Addendum #1
for
Prophetstown State Park Aquatic
Center

IFA Project No. E030221
Schmidt Project No. 2012-022.PAC

SEPT. 6, 2012

ADDENDUM NO. 1

5 SECTION/S404
 3/4" = 1'-0"

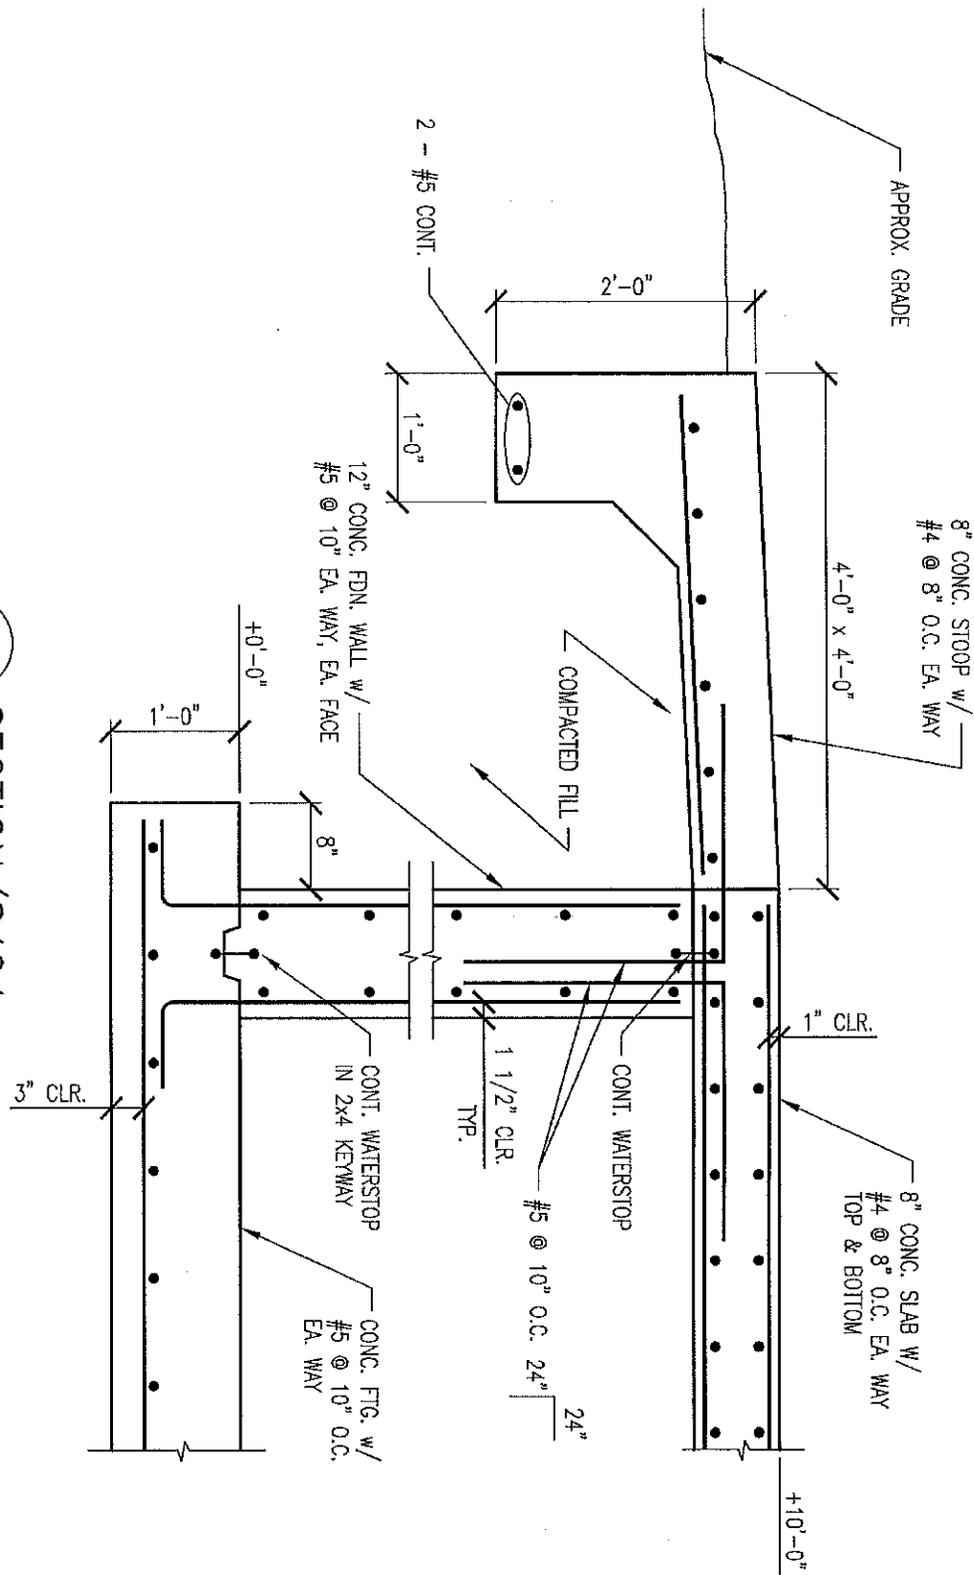
- A. Drawing Number S201
 1. Disregard the note calling for the laminated wood deck to be an alternate bid item. This work is base bid.
- B. Sheet S-202 - Foundation & Roof Framing Plans - Mechanical Room
 1. Section mark 4/S-403 shown on foundation wall on foundation plan should be marked 4/S-404.
 2. Provide section mark 8/S-202 at north exterior wall (foundation plan), east of Electrical Room 203 and at west exterior wall (foundation plan) between the concrete tank and Door 200.
 3. Provide section mark 5/S-404 at south wall (foundation plan) at two exterior door locations.

4. All piping greater than 4" diameter must be floor supported and not hung from the wood roof trusses.
- C. Sheet S-404 – Sections & Details
1. Section 4: Coordinate elevation of 6" perforated drain tile with site/civil drawings.
 2. Add Section 5/S-404 to this sheet.

1 Partial Grading Plan -- Addendum. No.1

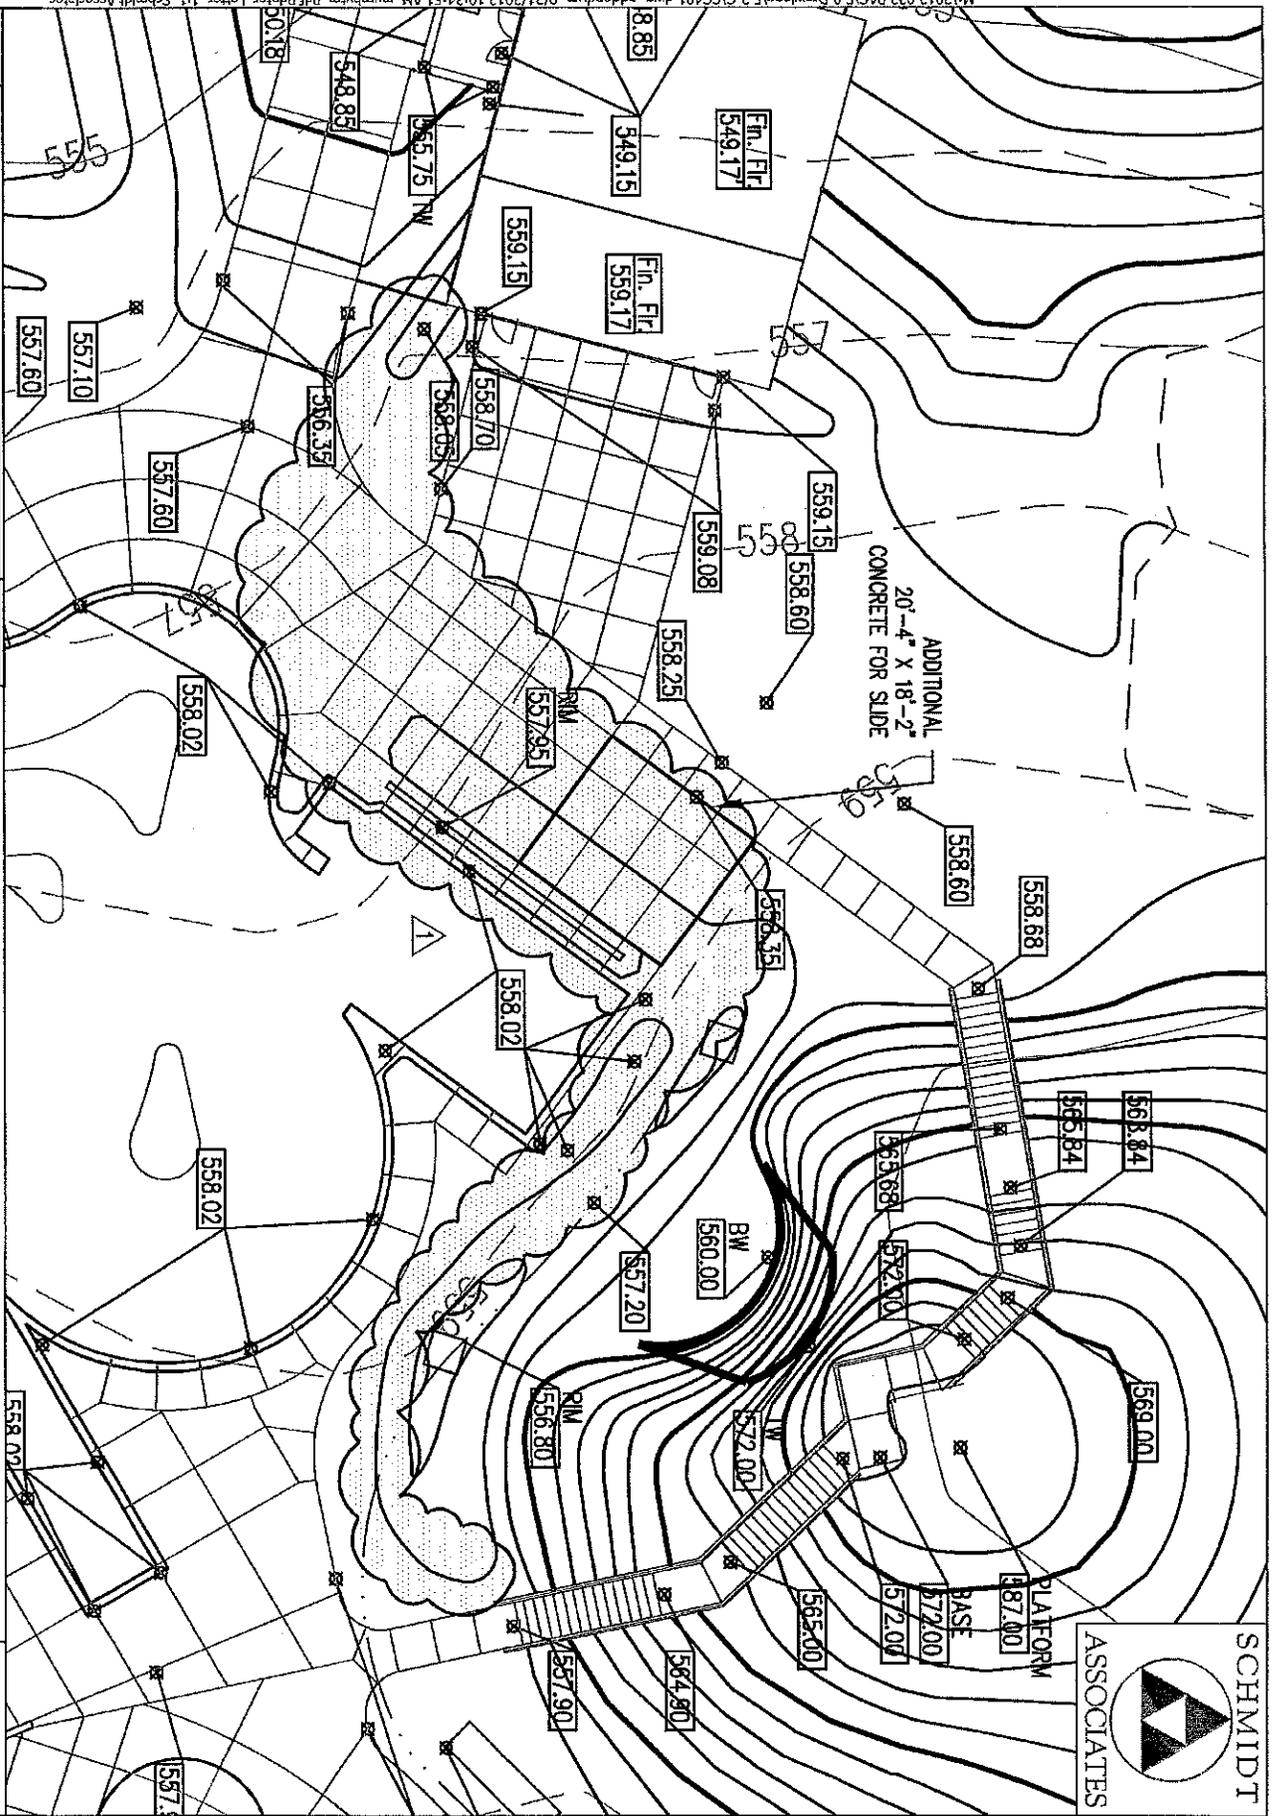
- A. Drawing CG401
 1. See attached Partial Grading Plan sketch indicating revisions to the Grading Plan for work to be done for Alternate No. 1 to add the second slide.

ALTERNATE NO.1 FOR
SECOND SLIDE
Drawing No. xxx
Project No.
2012-022-PAC

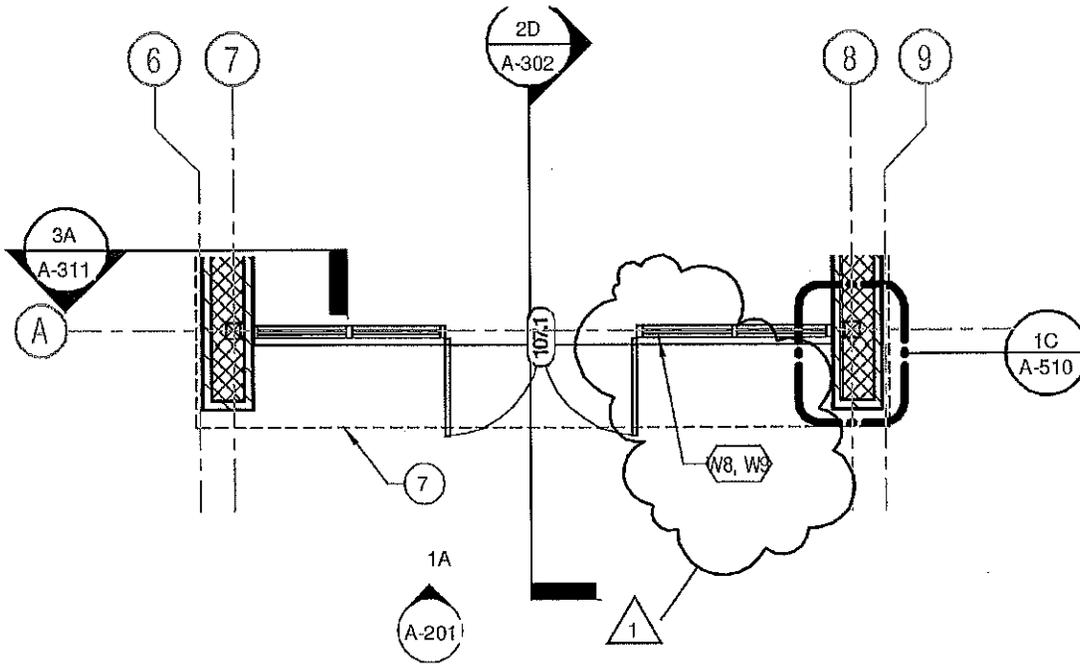
- B. Drawing CU101
 1. See attached Partial Utility Plan indicating miscellaneous revisions to the Utility Plan along with work to be included for Alternate No. 1 to add the second slide.

Addendum #1
BATHHOUSE FLOOR PLAN
 Drawing #: 2A/AFP01
 Date: 09/20/12
 Project #: 2012-022.PAC

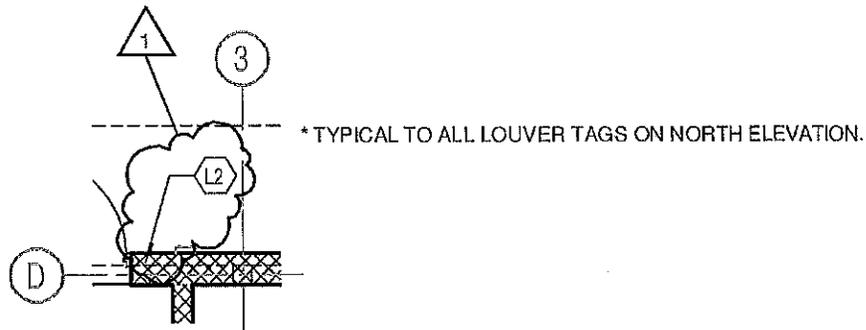
- A. Drawing Number: AFP01
1. Modify Plan 2A/AFP01 per the attached Sketch 2A/AFP01.
- B. Drawing Number: AFP02
1. Replace "Pump House Door Schedule" with attached Sketch -/AFP02.
- C. Drawing Number: AR-101
1. Modify Plan 2D/AR-101 per the attached Sketch 2D/AR-101.
- D. Drawing Number: A-201
1. Replace Elevation 3C/A-201 with attached Sketch 3C/A-201.
- E. Drawing Number: A-321
1. Add Section 2D/A-321 per the attached Sketch.
 2. Add Section 4D/A-321 per the attached Sketch.
- F. Drawing Number: A-600
1. Add Elevation L2 per the attached Sketch -/A-600.

2A ADDENDUM 1 - SEPTIC FIELD DOSING TANK
 1" = 20'-0"

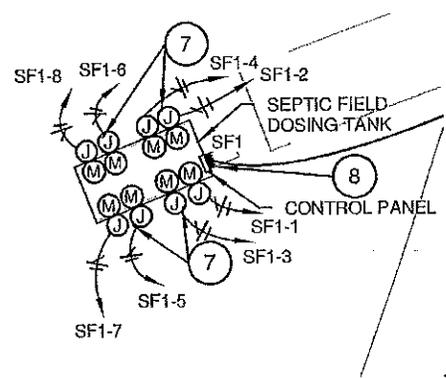
2. At Septic Field Dosing Tank there shall be a junction box per pump for a total of eight.
 3. Each pump shall be connected to 20A-1P circuit breaker (2#12, 1#12GND, ¾"C) in Panelboard SF1 through Pump Control Panel. Division 26 Contractor to install Pump Control Panel provided by others on back of unistrut frame for Panelboard SF1. Div. 26 Contractor to connect control panel to 20A-1P circuit breaker (2#12, 1#12GND, ¾"C) and connect circuits for each pump through control panel to junction box at tank, and provide conduit seal-offs.

4. See attached Panelboard Schedule SF1, Sketch 2A-ES101a.
 5. See attached Sketch 2A-ES101b.
- B. Drawing Number E-101
1. Add WP/GFCI receptacle on north wall of Column Line C-15. Connect to circuit BHP2-34.
